Project: ROTOKAURI NORTH PRIVATE PLAN CHANGE (PC7) **Memo:** One **Page:** 1 of 27

Topic: Landscape and Visual Effects – Technical Review & Reporting

Date: 30 August 2021

Attention: Jamie Sirl / Craig Sharman - Hamilton City Council

Figure 6: Neighbourhood Park Location - Optimised (500m distance (Euclidean))

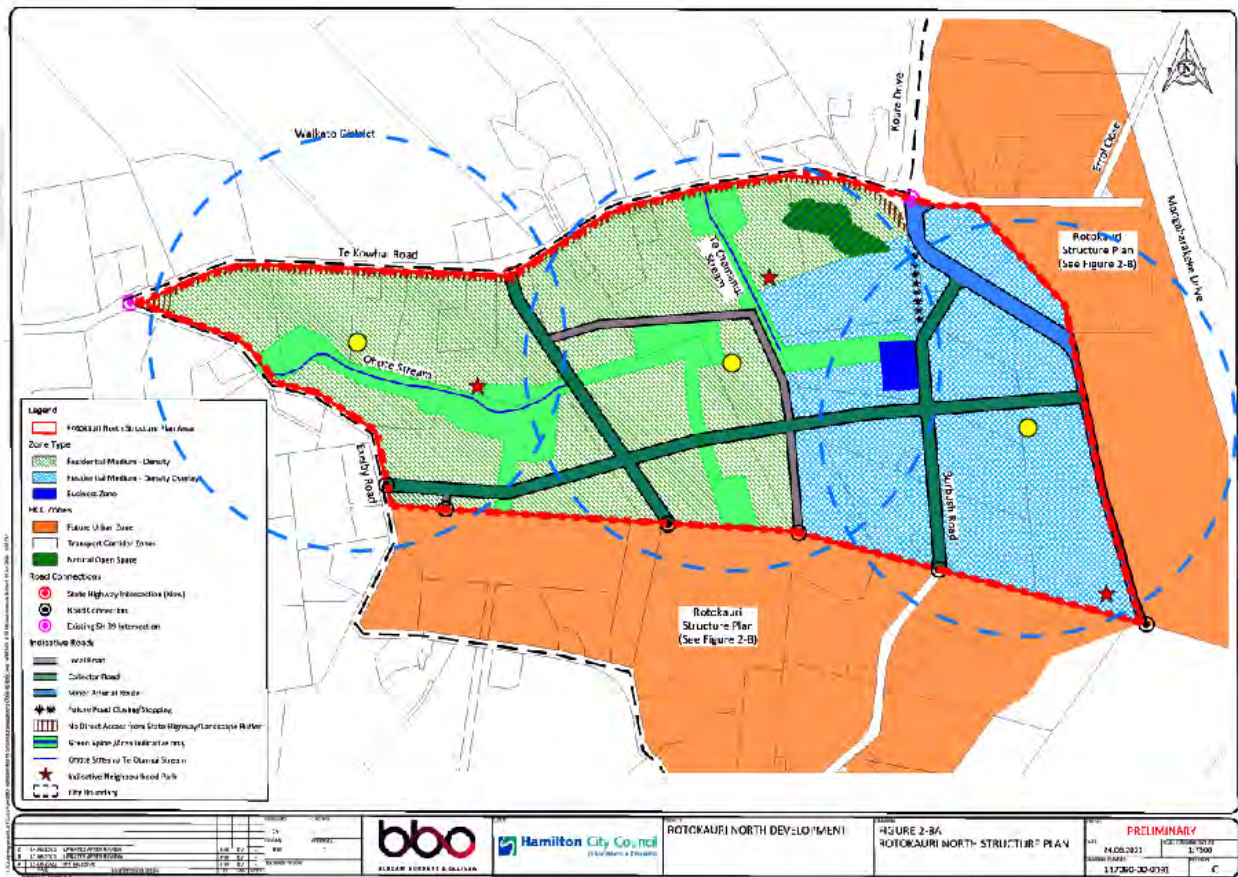
I support the proposed amendments to rule 27.7.8 as this provides some certainty around the purpose and minimum sizes for the identified neighbourhood parks. The adoption of this rule would likely require the location of the neighbourhood parks shown on the proposed structure plan to be reconsidered as their present location would make it difficult to meet the 500m walking distance provisions.

The three yellow dots in the following figure shows where neighbourhood parks would need to be located to best achieve this rule if only 3 parks are to be provided for. The dashed blue circles represent a 500m (Euclidean) distance from each potential neighbourhood park location (proposed).
